Addendum D2

re: **City of Berne**
New Municipal Maintenance Building
335003.00

date: **February 16, 2024**

ADDENDUM NO. 2
To the Contract Document for the

PLANT MATERIAL LIST*

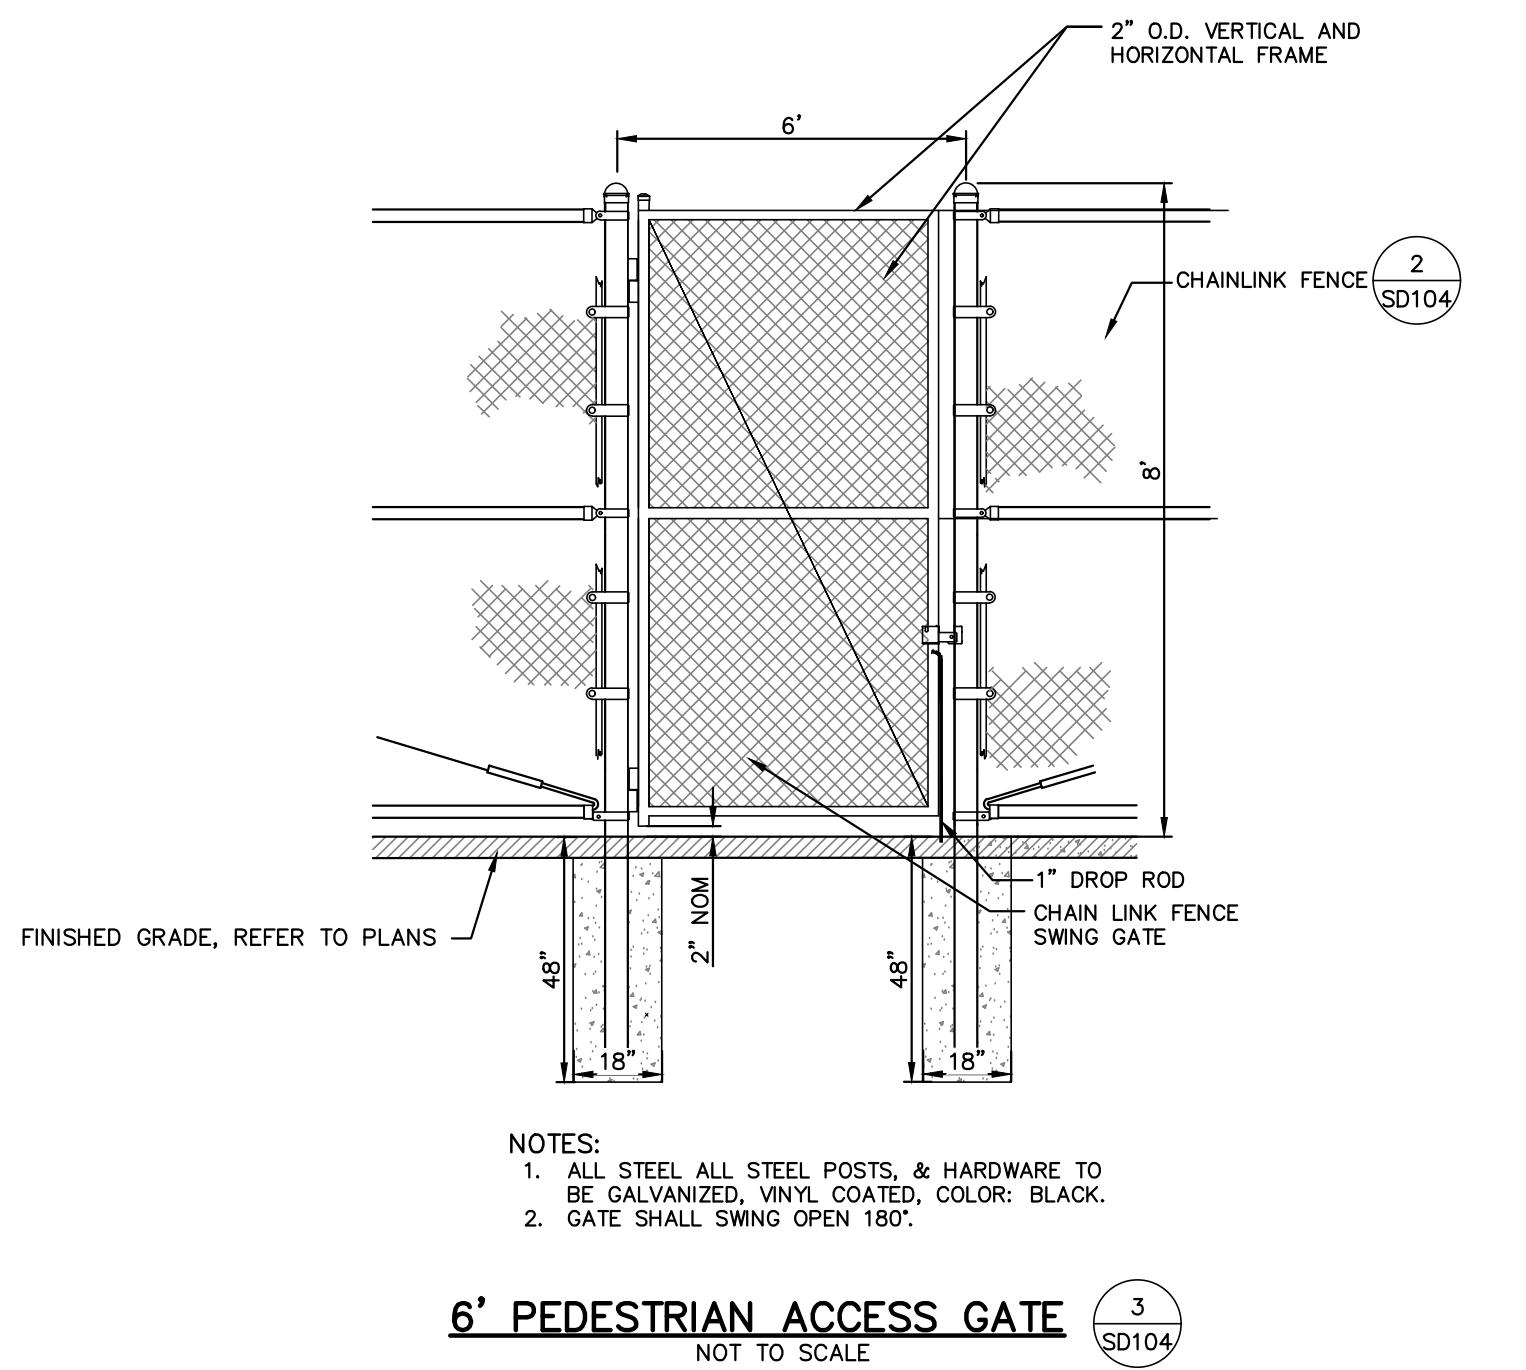
9. Plan Sheet SD104:
 - A. **REVISE** Detail 4 to include a finish of bronze anodized.

1. This project has a 30' and 40' flag pole and the only place we can find this referenced is the civil plan directs you to detail 4/SD104. This provides the model of each, but there are several different finishes for each model. Can you clarify the finishes for the flag poles please.

RESPONSE: Plan sheet SD104 Detail 4 has been updated to include the finish of bronze anodized for the flag poles.
